No. **2002-1**

SUBJECT: Mandatory Jetting Change

YEAR	MODEL	MODEL NUMBER	SERIAL NUMBER
2002	MX Zx 440 Racing	1948/2120/2129	All

**SUBJECT: A) Clutch Lever Pin
B) Octane Selector Switch**

B) OCTANE SELECTOR SWITCH

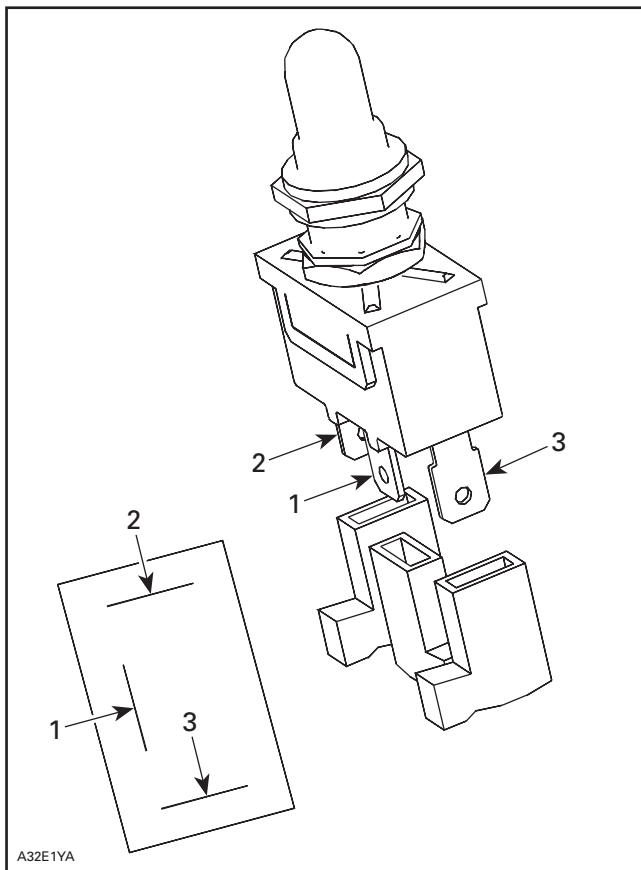
Some of the above-mentioned units may have the octane selector switch wires at the wrong position.

In order to correct this situation, dealers/distributors need to relocate the wires on the selector switch as per the following instruction:

IMPORTANT: Center prong has to be positioned toward the front of the vehicle.

- TAN wire connects to the center prong,
- BLACK wire connects to the right side^① prong,
- GREEN wire connects to the left side^① prong.

1. Center prong (must be placed toward front of vehicle) (TAN wire)
2. Right side prong (or interior) (BLACK wire)
3. Left side prong (or exterior) (GREEN wire)

1. Surface prepared

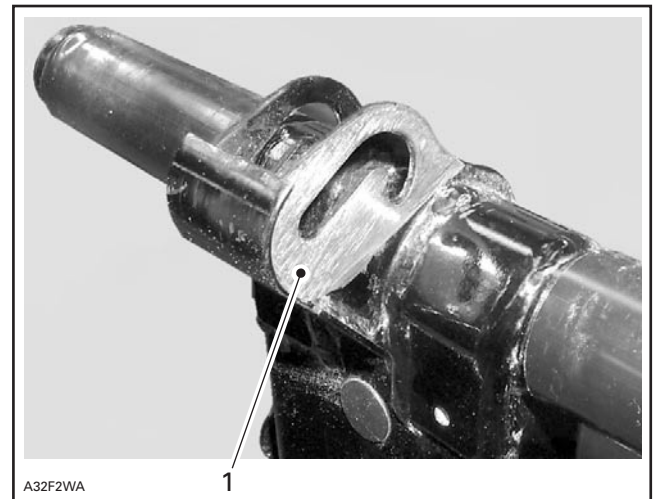
Under racing application, the top bolt of the rear shock may come loose and allow the shock to move on the rear arm slot.

Using appropriate tools and sand paper, remove paint on right side of suspension arm, in top shock hole area.

To rectify the situation, a support plate can be welded on rear arm.

1. Weld plate here

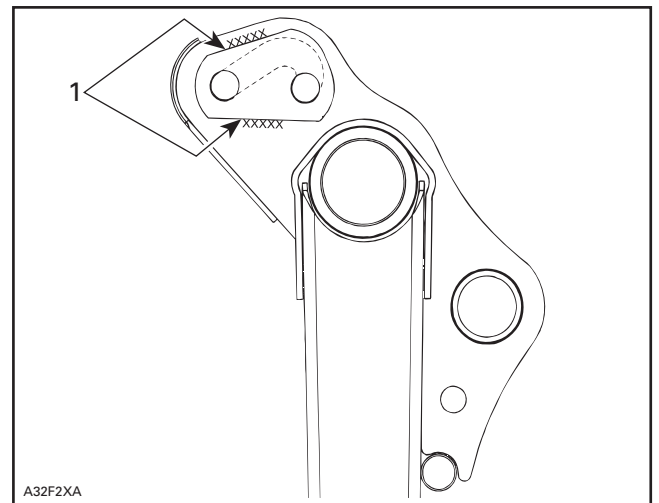
Install new plate on right side of suspension arm and weld it in place.

Repaint the area with black paint (P/N 413 401 000).
 Reinstall rear arm on suspension.
 Reinstall suspension under vehicle.
 Reinstall shock in place. Screw shock in farthest hole for standard setting or in the nearest hole for a less aggressive suspension behavior.

Replace the top shock flanged nut with new regular nut (See PARTS REQUIRED on first page). Always install the nut on plate side.

A32F3EA

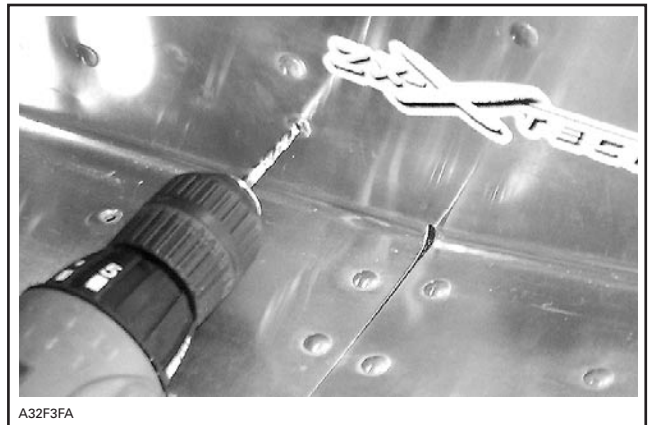
Under racing application, especially when track studs are used, tunnel may develop cracks on rear portion, near angled up split. If this occurs, cracks must be stopped and a reinforcement plate can be installed.

Stop the crack using a 1/8 inch drill. See photo.

Drill the lowest rivet near angled up split.

Install bracket to tunnel using the hole just drilled.

A32F3HA
RIVETING SEQUENCE

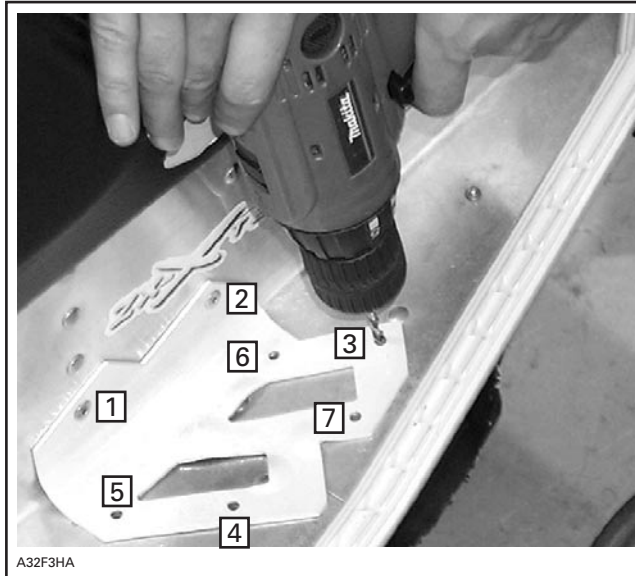
Drill the second tunnel side hole and rivet bracket. Push and hold down bracket to provide a good contact between footrest and bracket, then drill footrest and rivet as per next photo.
